TOWN OF COTTAGE GROVE  
PLAN COMMISSION MINUTES  
NOVEMBER 26, 2025

**RE:** Skaar Pit (Huston) Business Park Rezoning, Preliminary Plat, Certified Survey Map (CSM)

**CONCEPTUAL RURAL BUSINESS PARK DEVELOPMENT PLAN**  
**HIGHWAYS 12/18/N INTERCHANGE—NORTHEAST QUADRANT**  
**TOWN OF COTTAGE GROVE COMPREHENSIVE PLAN**  
**DANE COUNTY, WISCONSIN**

Subject: Proposed Skaar Pit Development Preliminary Plat Review

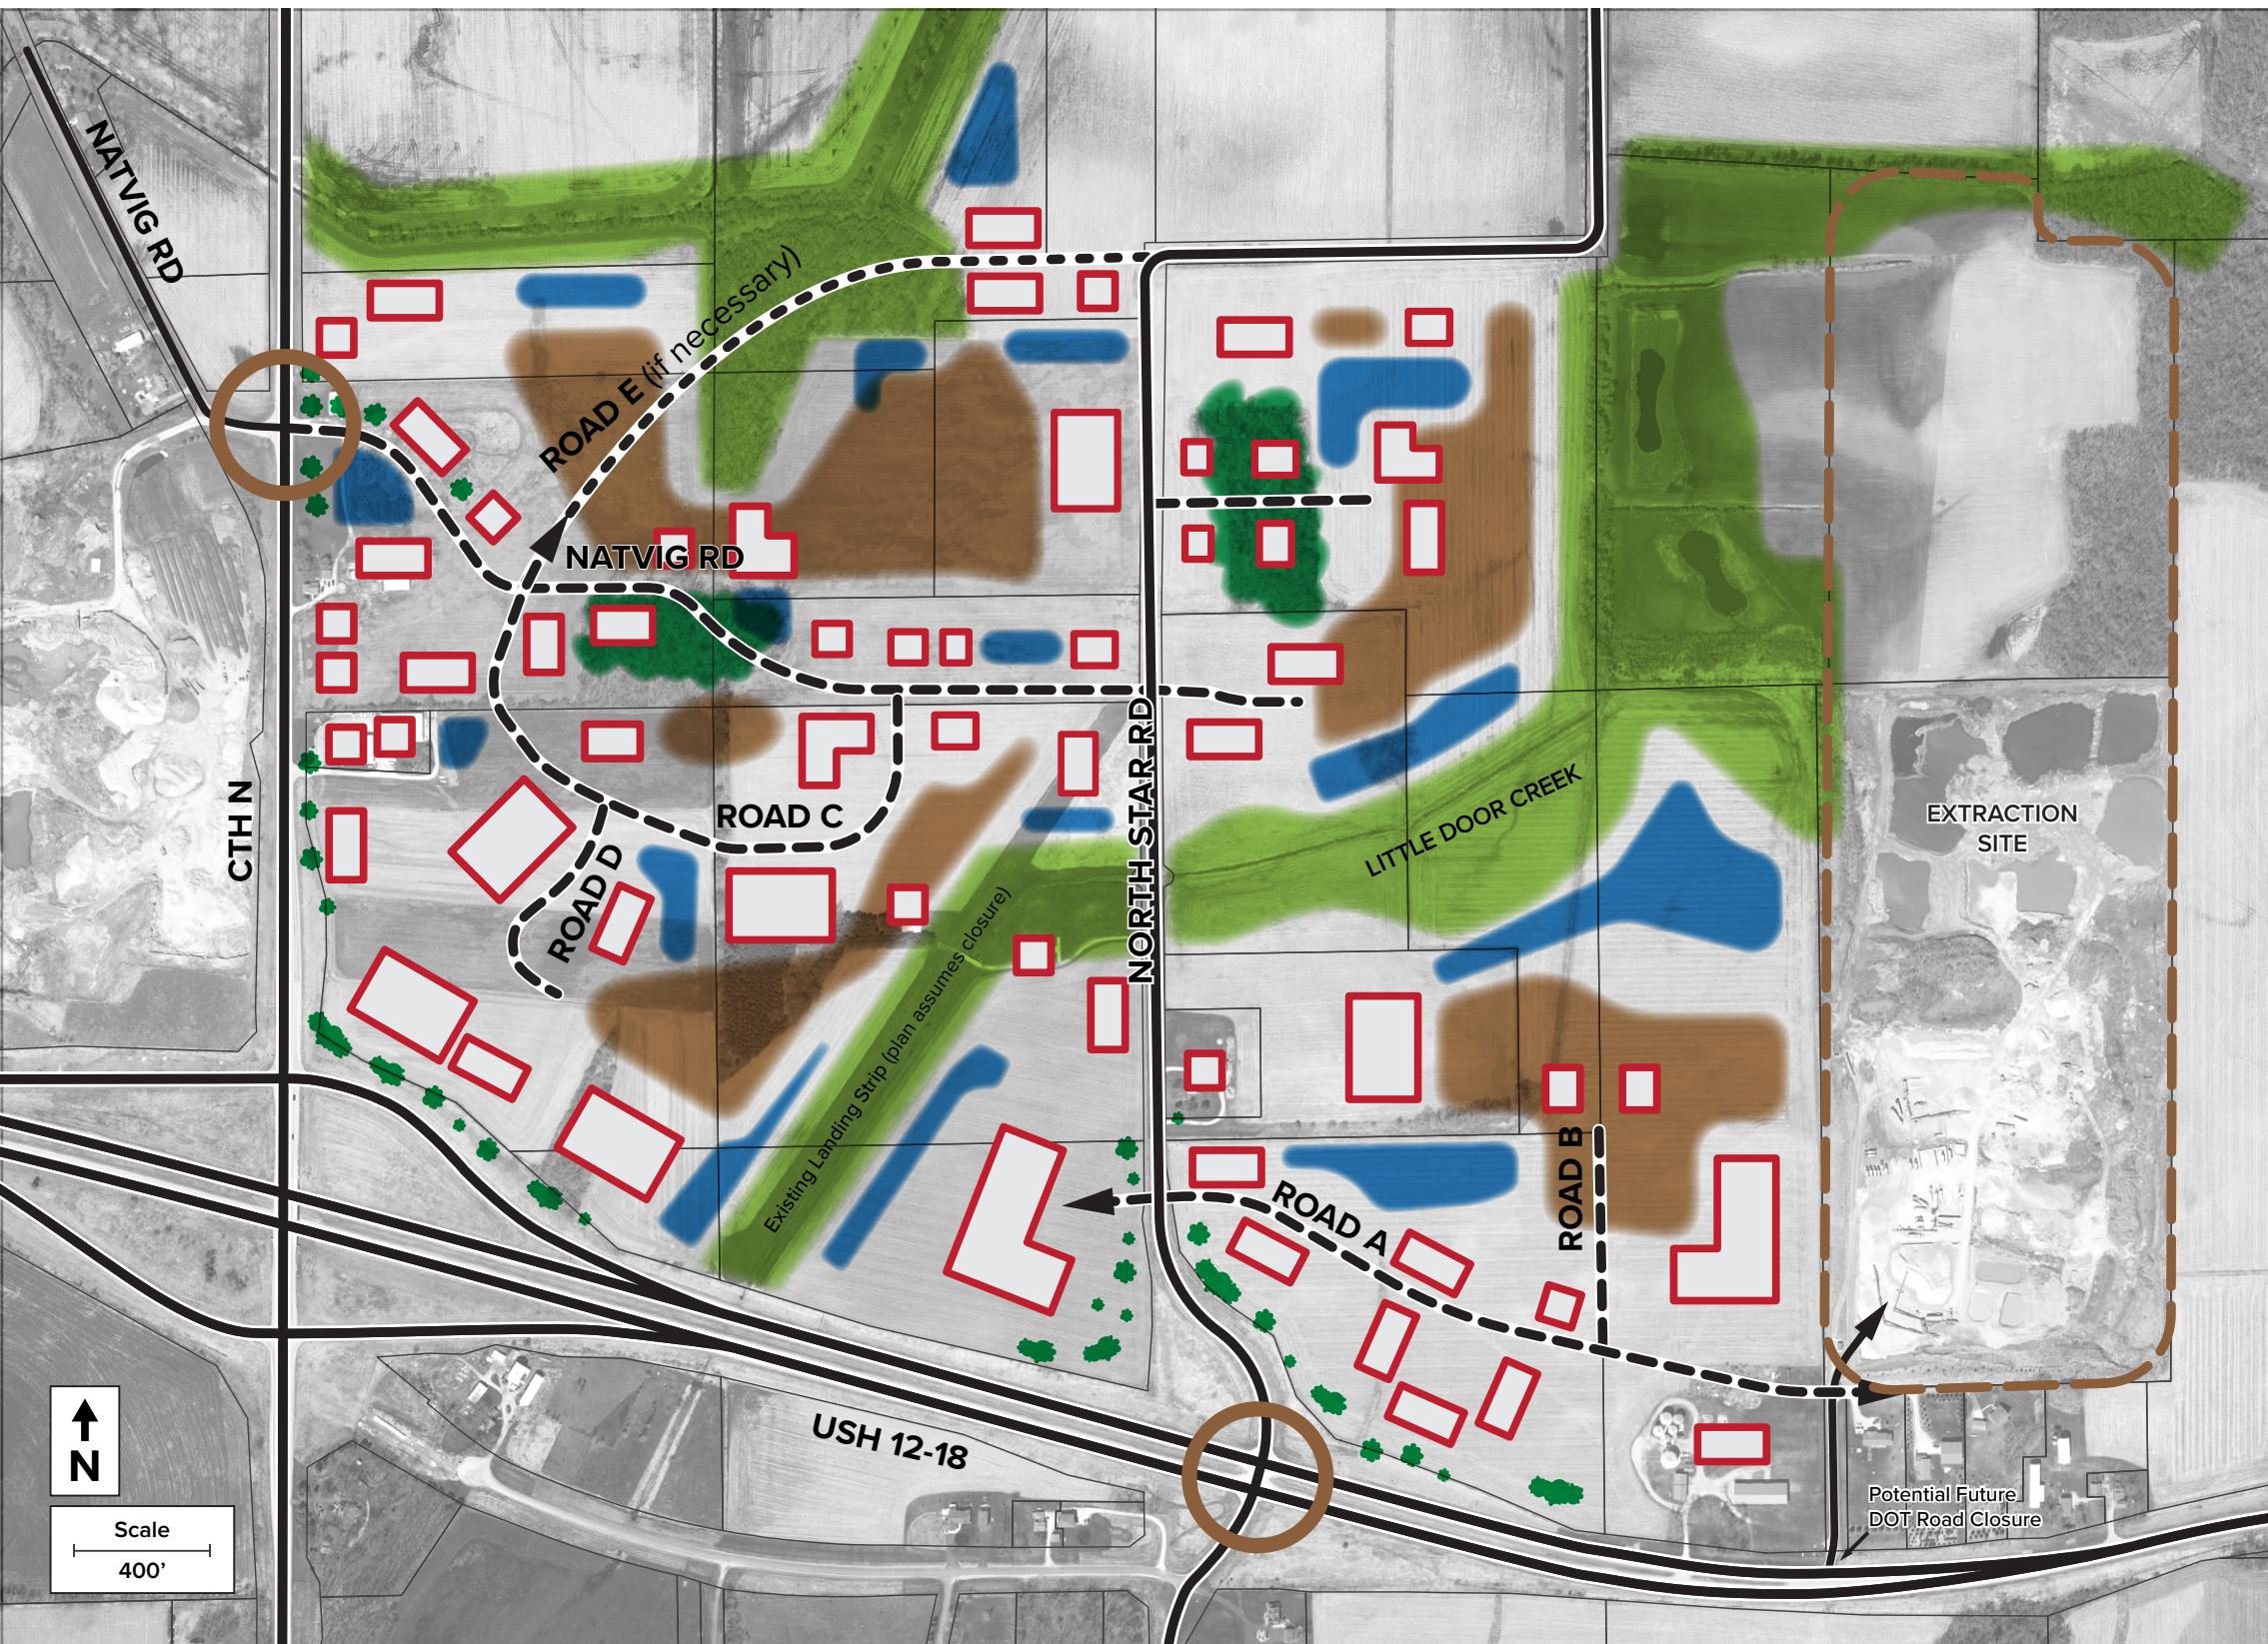
- a. Figure 9 of the Comprehensive Plan suggests land uses "that emphasize storage (particularly outdoor storage) and outdoor display and activities should be minimized." Per the attached Plan map, some more interior parts of this proposed development are indicated as acceptable for larger outdoor storage yards (brown) due to lower highway visibility. The applicant has proposed the attached deed restrictions to address impacts associated with outdoor activities, including that outdoor *storage* would require a conditional use permit, could not be located within 200 feet of any highway, would be screened from all streets and highways, and cannot be the sole use without a building.

- e. The Town Plan also suggests potential for a secondary road connection to the northeast (labeled “ROAD E (if necessary)” on attached map) to connect at the northern “bend” of North Star Road, through parcel 071128482510 (Larry Skaar). Referring to features shown on the preliminary plat map, this potential road would have to weave among a wooded, steep sloped drumlin and a floodplain to its immediate north. As a second “N-to-North Star” road connection, it would also seem to have limited additional value for business marketing and success, traffic movement, and public safety. I advise this secondary road connection not be required.
